SERVICE BULLETIN

Classification: RS11-004	Reference: NTB12-004	Date: January 9, 2012
-----------------------------	-------------------------	--------------------------

SUPPLEMENTAL RESTRAINT SYSTEM (SRS) FRONT DOOR SIDE SATELLITE SENSOR INTRODUCTION

APPLIED VEHICLES: All 2011-2012 Nissan vehicles with SRS DTC B1338 and/or B1345 logic

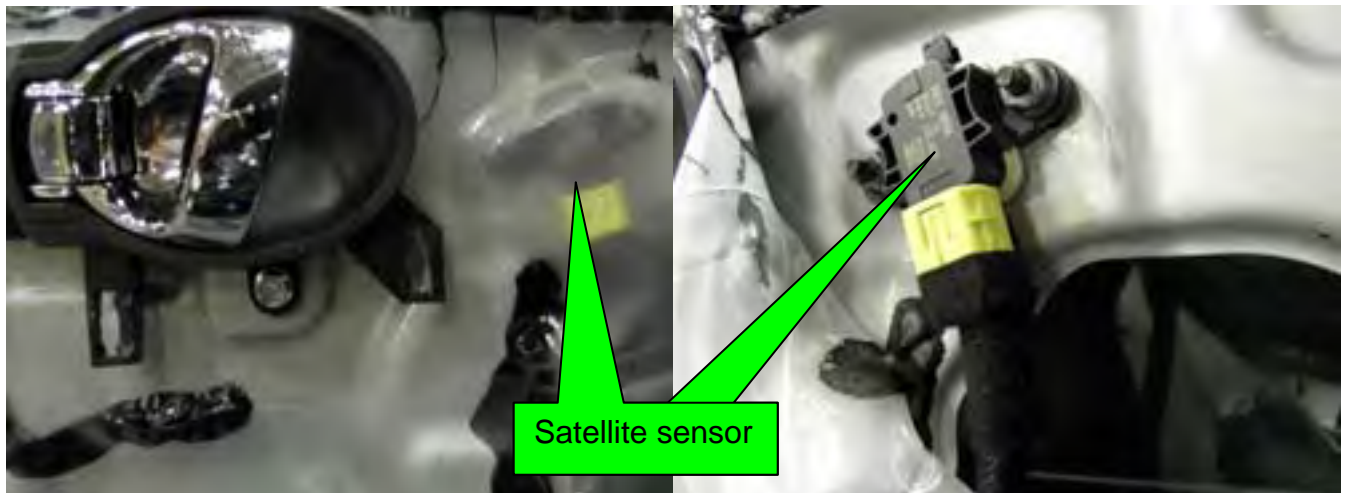
The Applied Vehicles now come equipped with a “Front Door Side Satellite Sensor”, in addition to the pre-existing Side Air Bag Satellite Sensor found in the pillar.

These Sensors have new Diagnostic Trouble Codes (DTC) associated with them.
